CHUCK E. CHEESE'S PIZZA.
6917 N. W. EYDESSWAY
#889

CHUCK E. CHEESE'S
6897 N. W. EXPRESSWAY
OKLAHOMA CITY, OK 73132

DEMOLITION PLAN

FLOOR PLAN

01 FLOOR PLAN
SCALE: 1/8" = 1'-0"

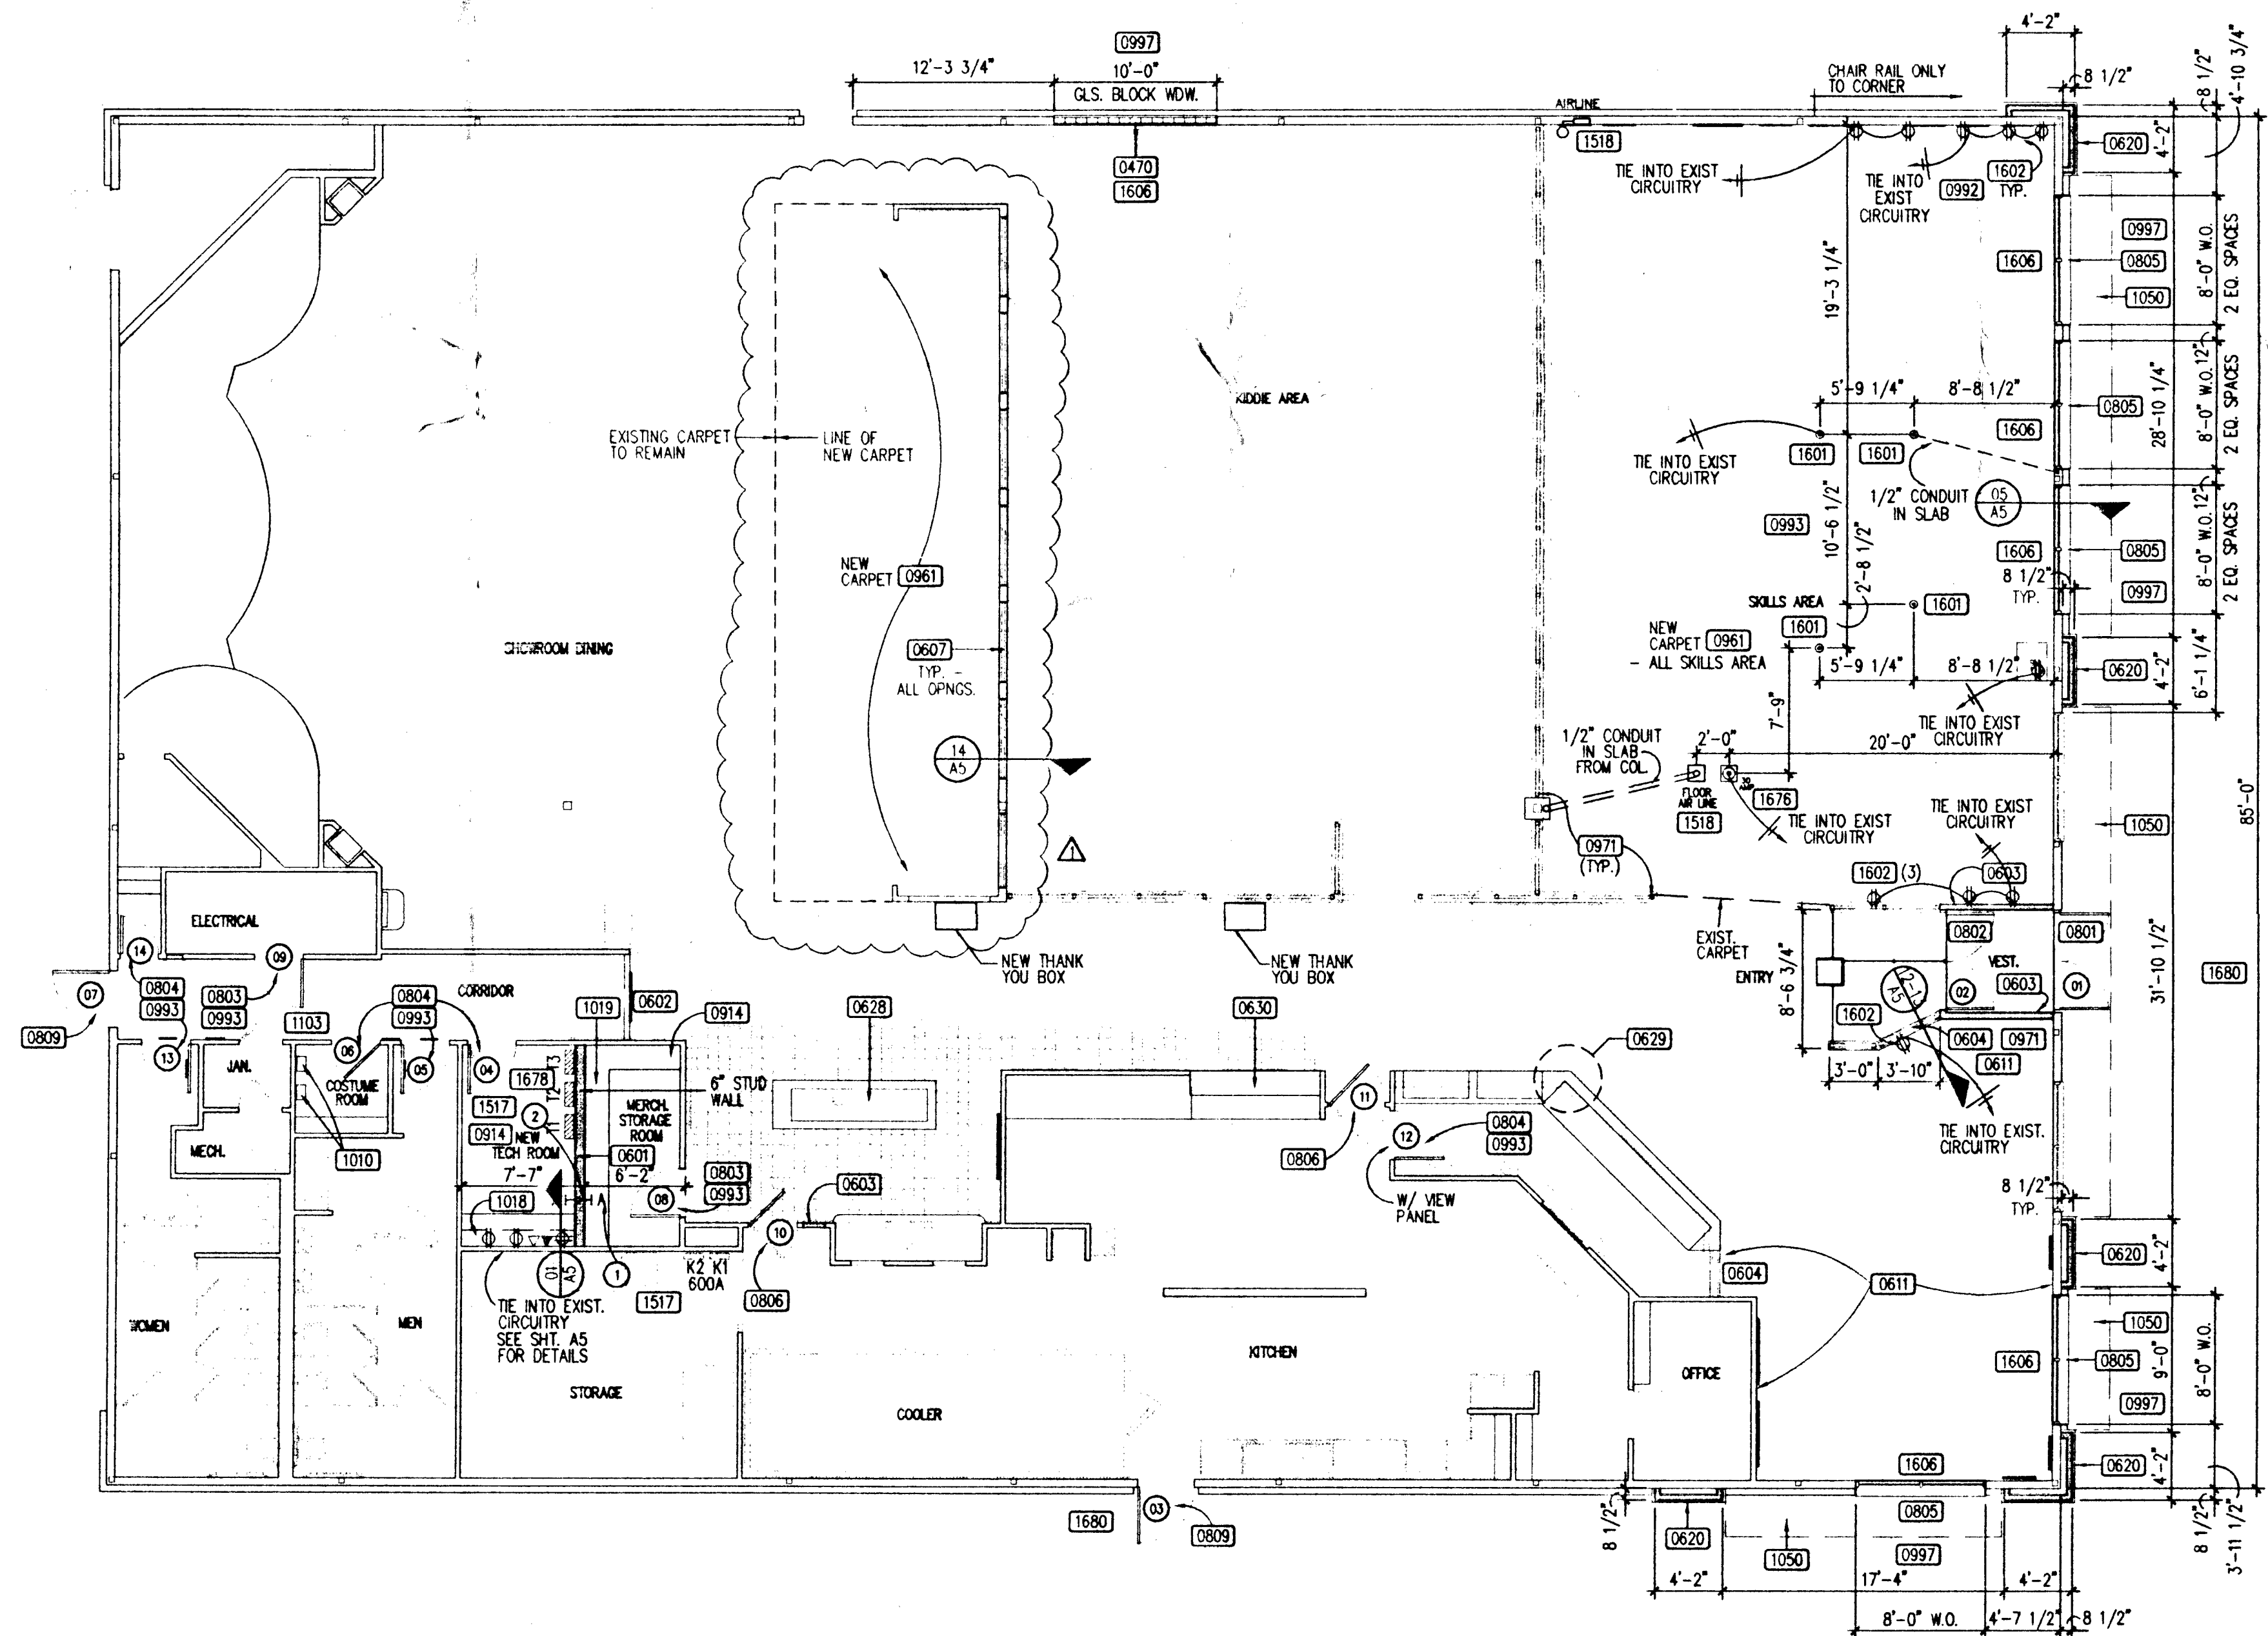
GENERAL NOTES AND COMMENTS AS PER CITY REQUIREMENTS:
POSTING STRUCTURE - OCCUPANT LOAD MUST BE POSTED AS PER 1996 BOCA SECTION 1008.0
OCC. LOAD: 350
MINIMUM UNIFORMLY DISTRIBUTED LIVE LOADS MUST BE: LIVE LOAD 100 PSF AS PER 1996 BOCA
SECTION 1606.0
STRUCTURES MUST COMPLY WITH ENERGY CONSERVATION REQUIREMENTS AS PER CHAPTER 13, 1996 BOCA.
SMOKE DETECTORS REQUIRED AS PER ORD. #15500
INSTALL SAFETY GLAZING AS REQUIRED AS PER 1996 BOCA SECTION 2405.0
EMERGENCY EGRESS LIGHTING & ILLUM. EXIST SIGNS TO COMPLY W/ CITY LOCAL CODES.
PANIC HARDWARE REQUIRED EXITS.
